TALLAWONG STATION **PRECINCT SOUTH**

ADDENDUM URBAN DESIGN REPORT

Rev. E_10.12.2020

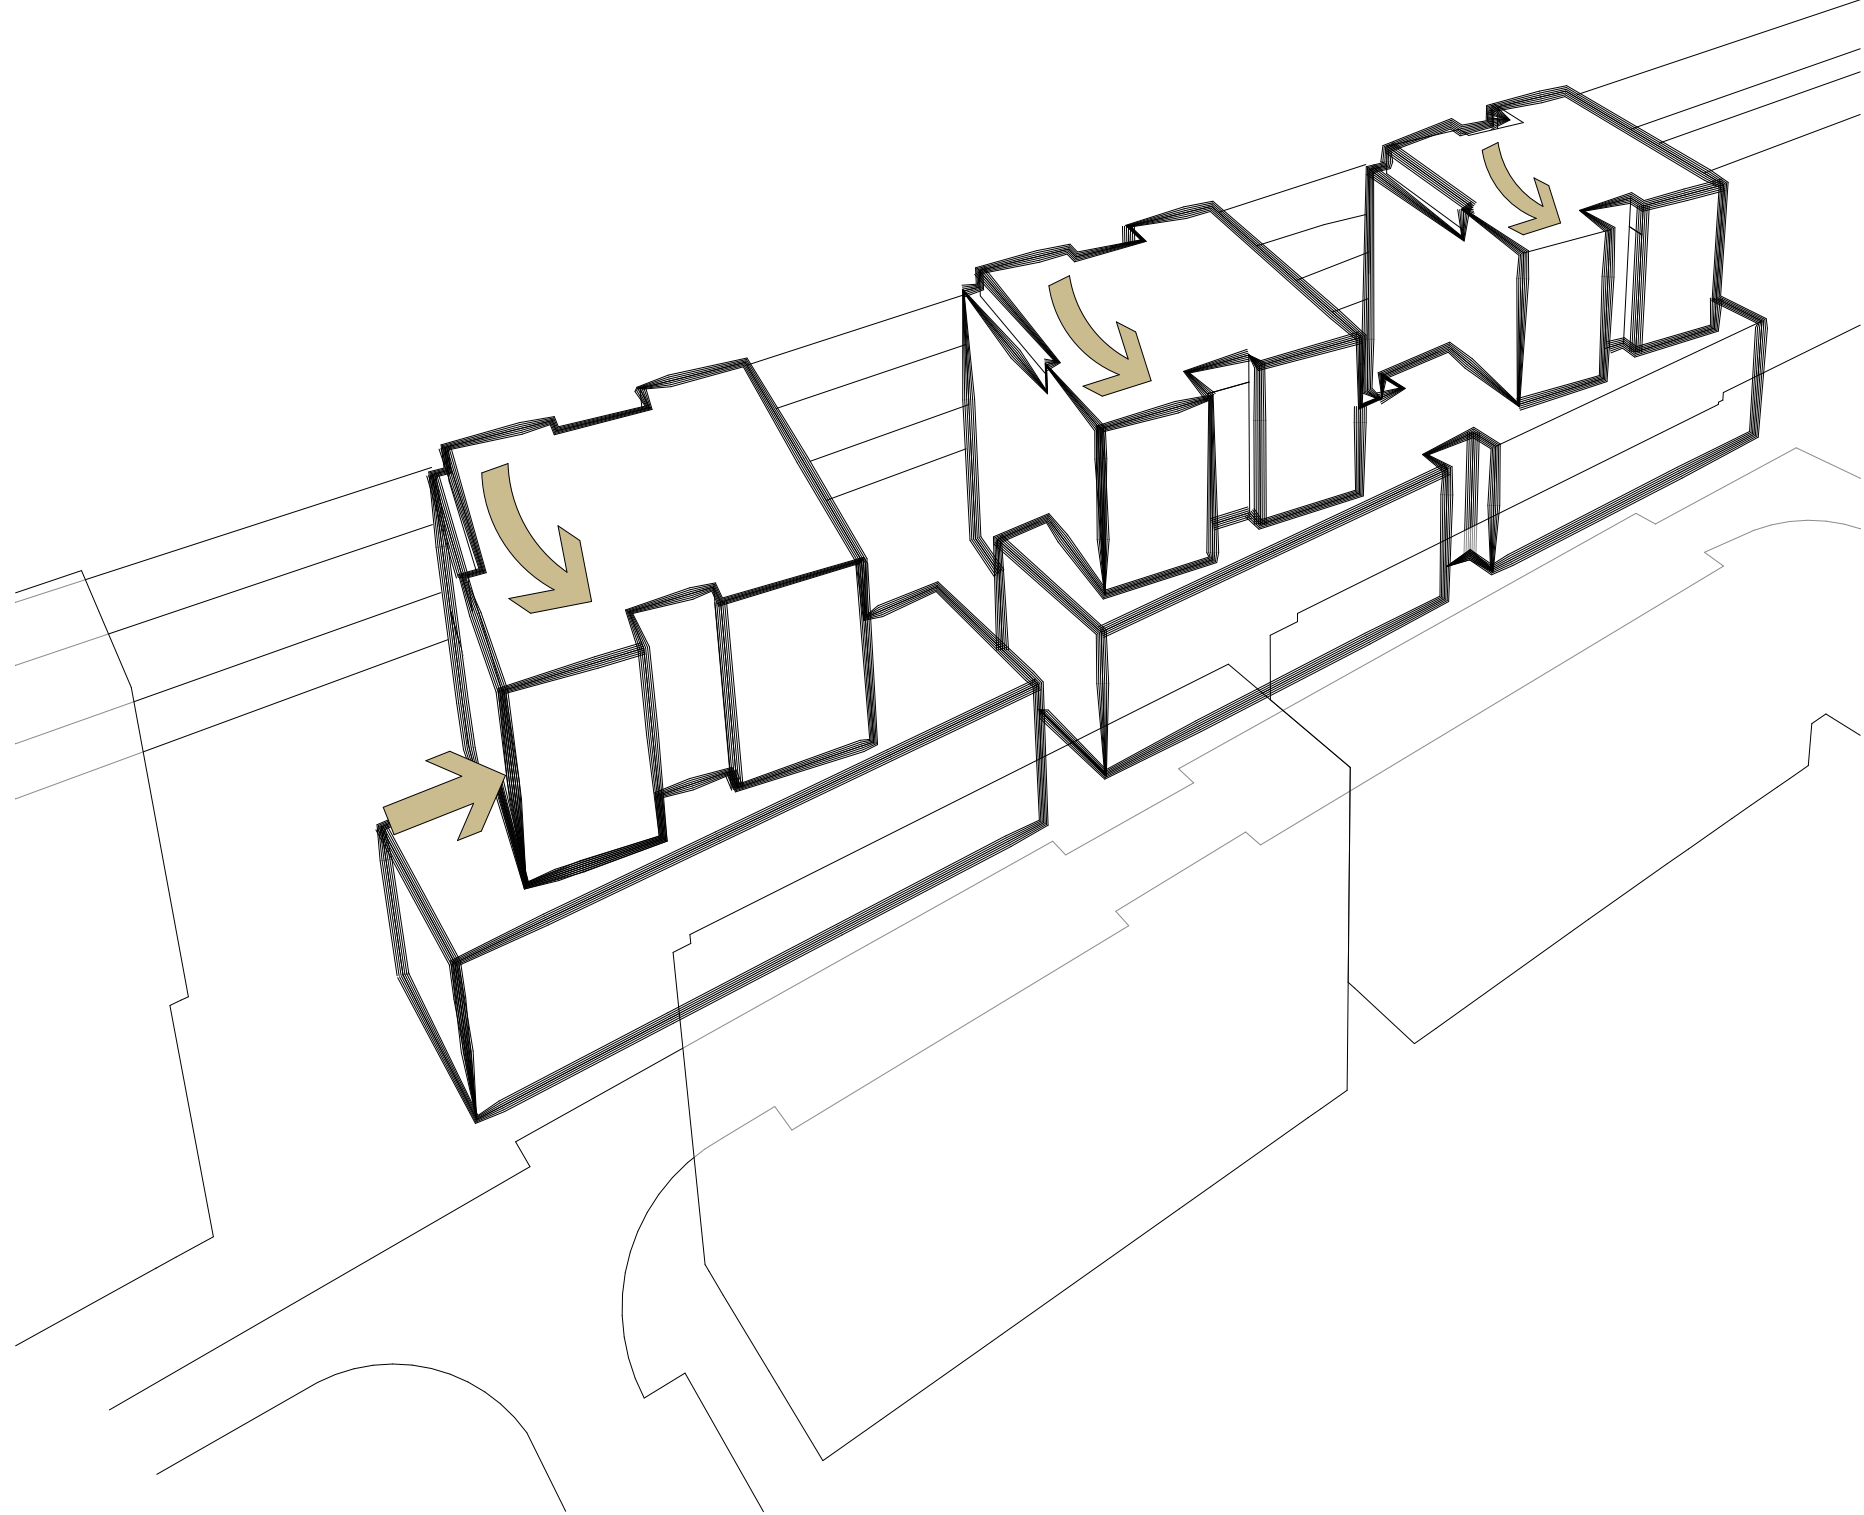
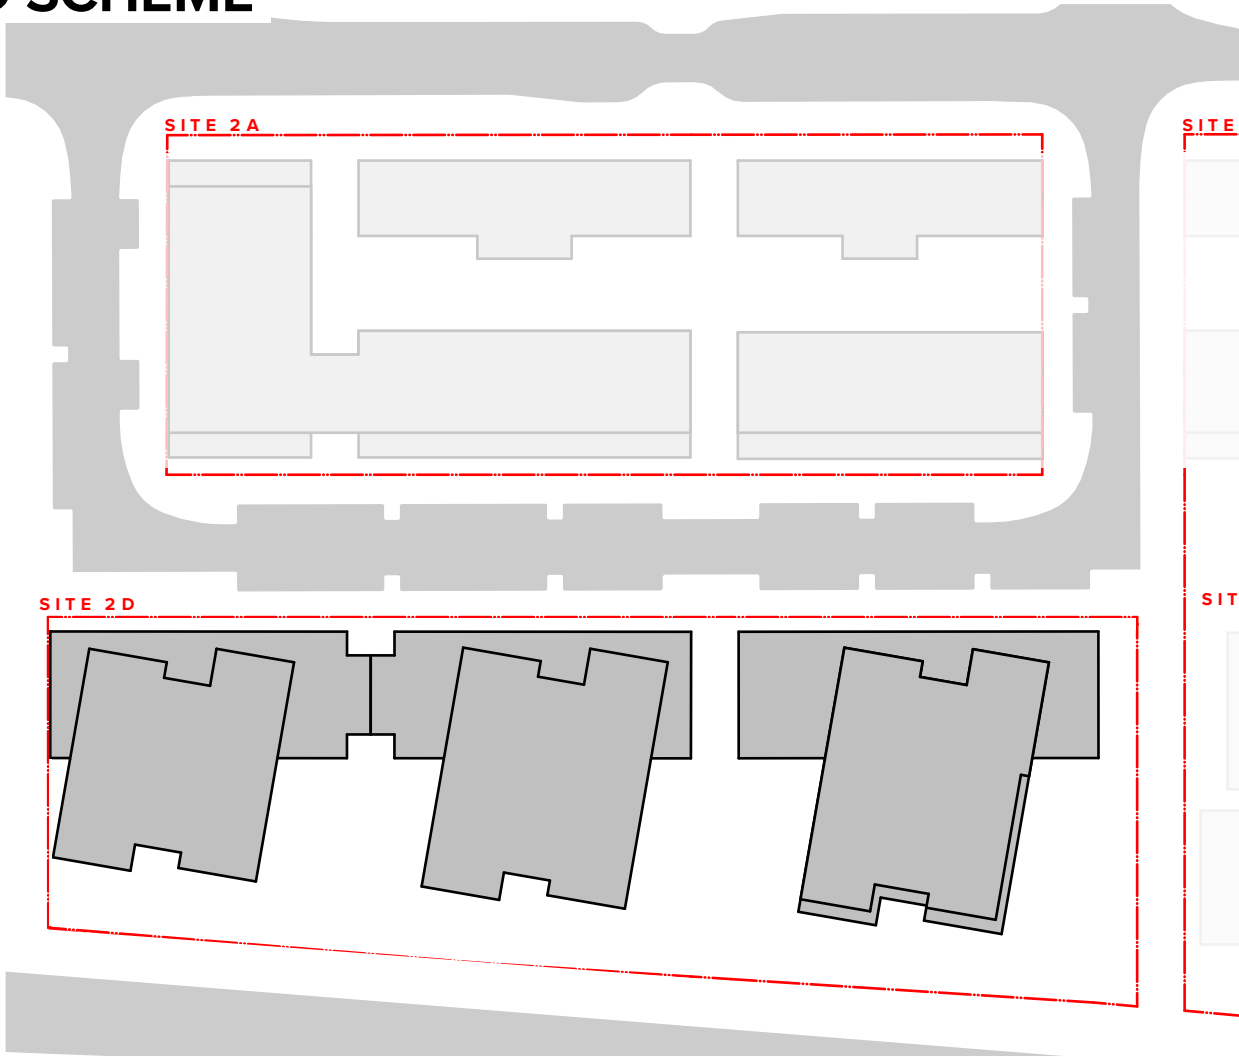
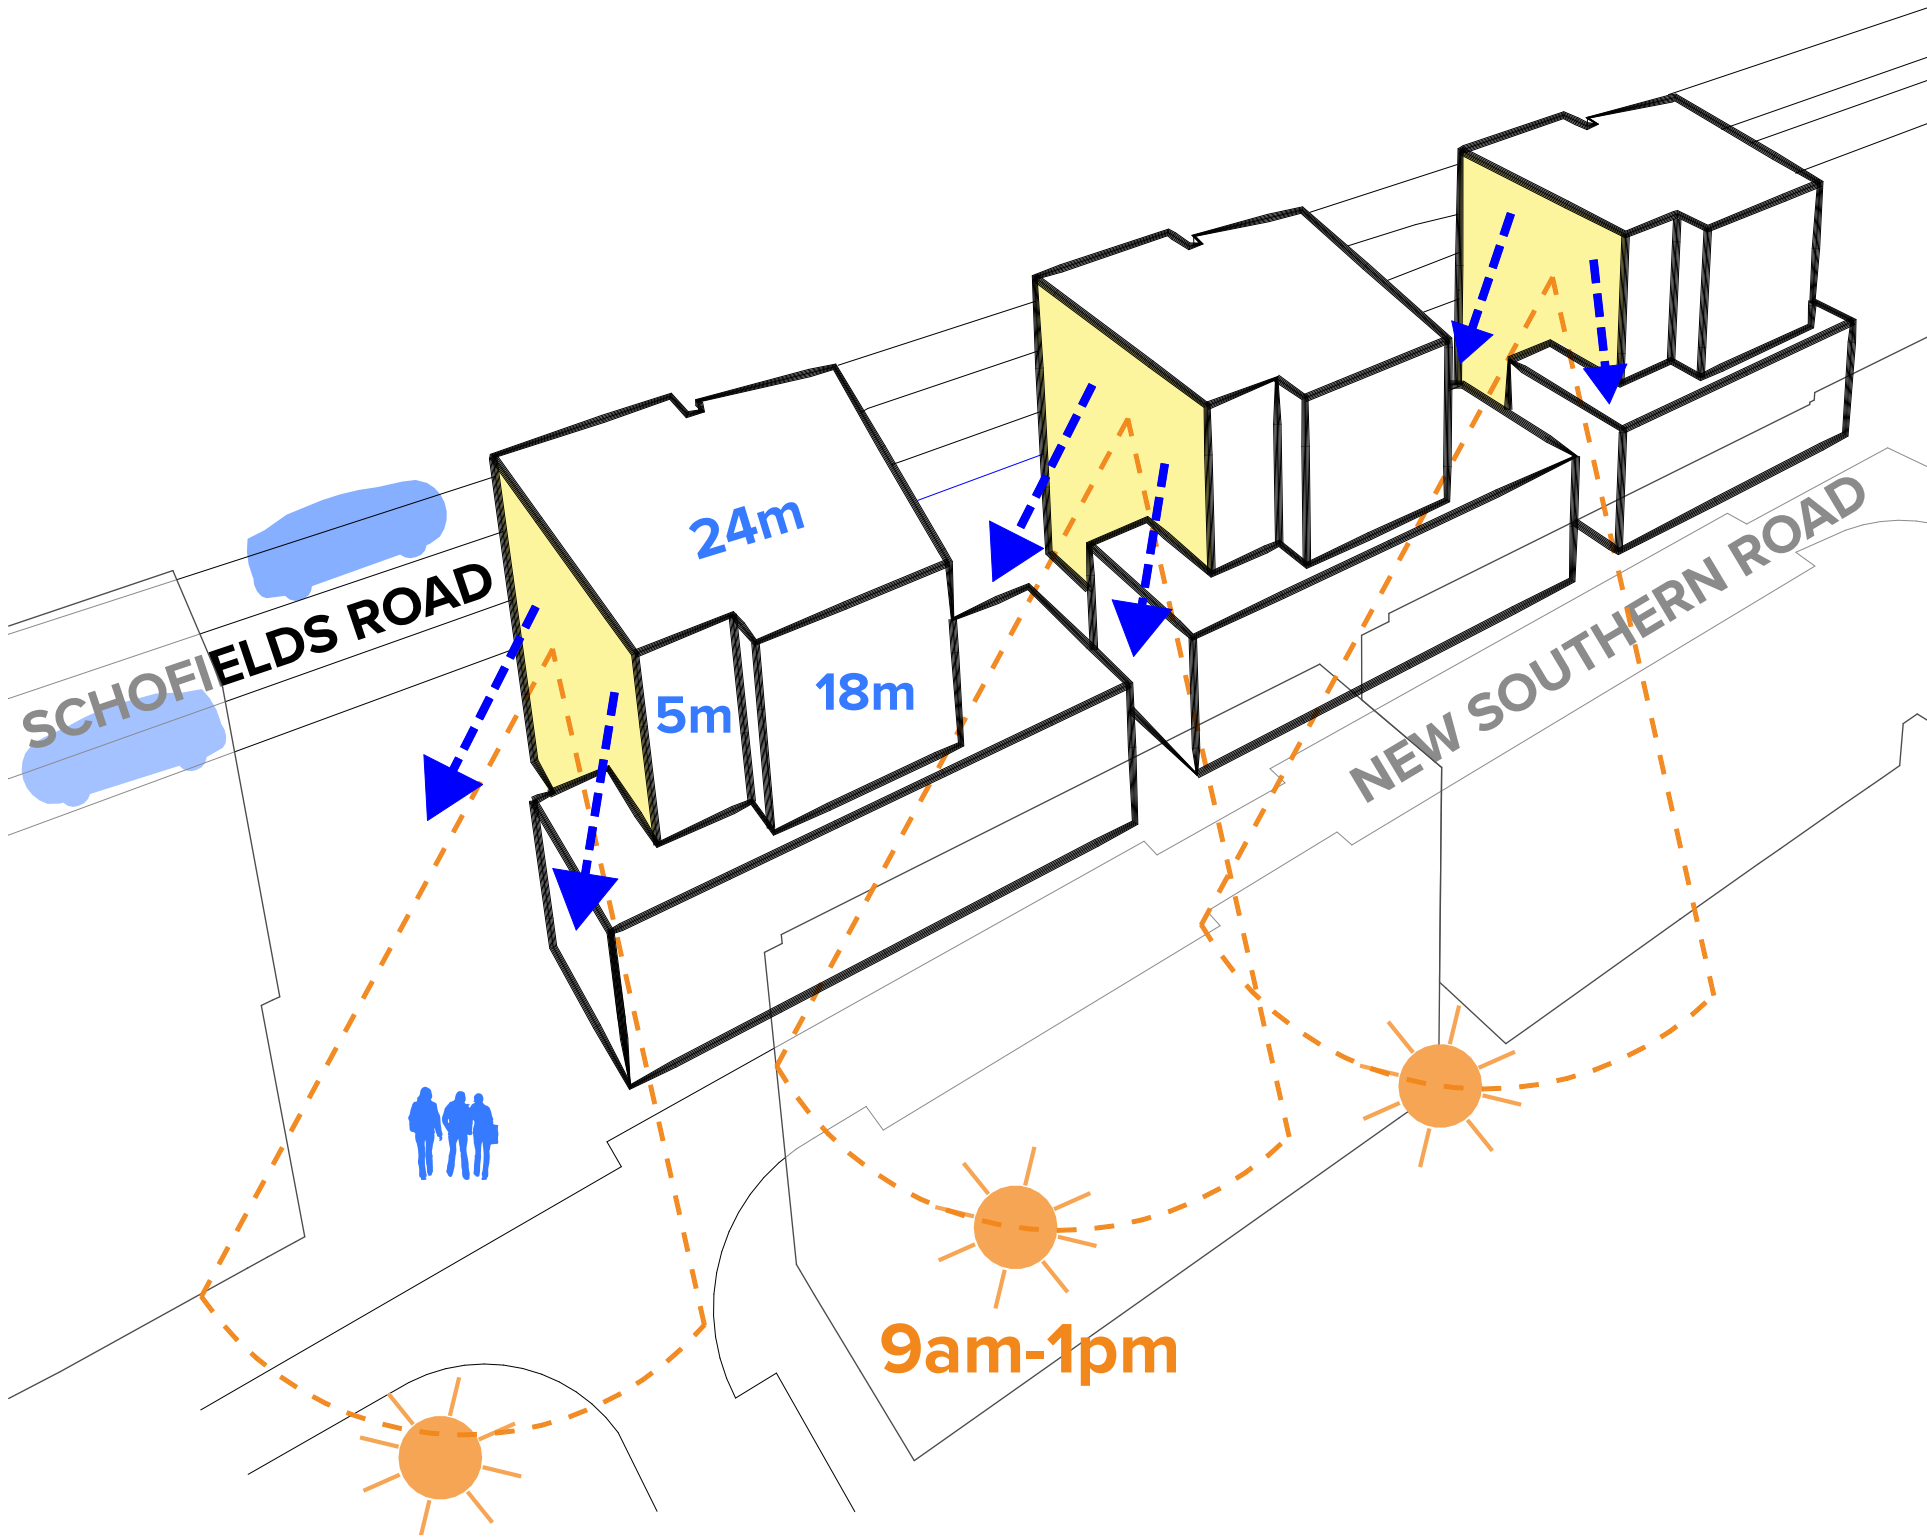
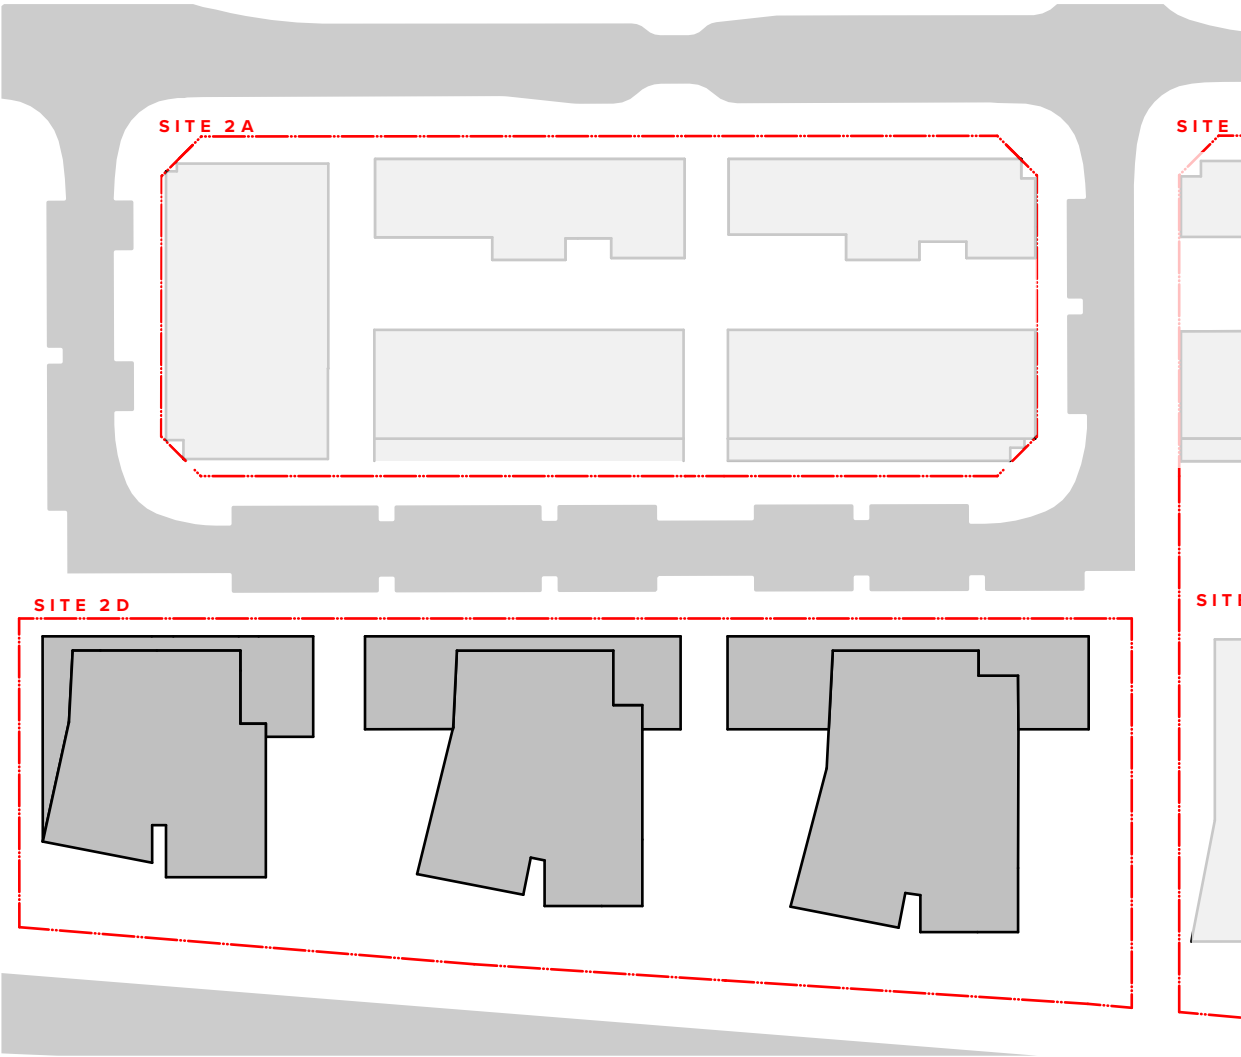
- ✓ Realign facade to orientate outlook north in response to solar access site building alignments
- ✓ Reduce upper building widths to the New Southern Road, increasing separation and outlook from the public domain
- ✓ Upper level setback to Schofields Road removed and balanced across new building form. Primary setback to Schofields Road maintained
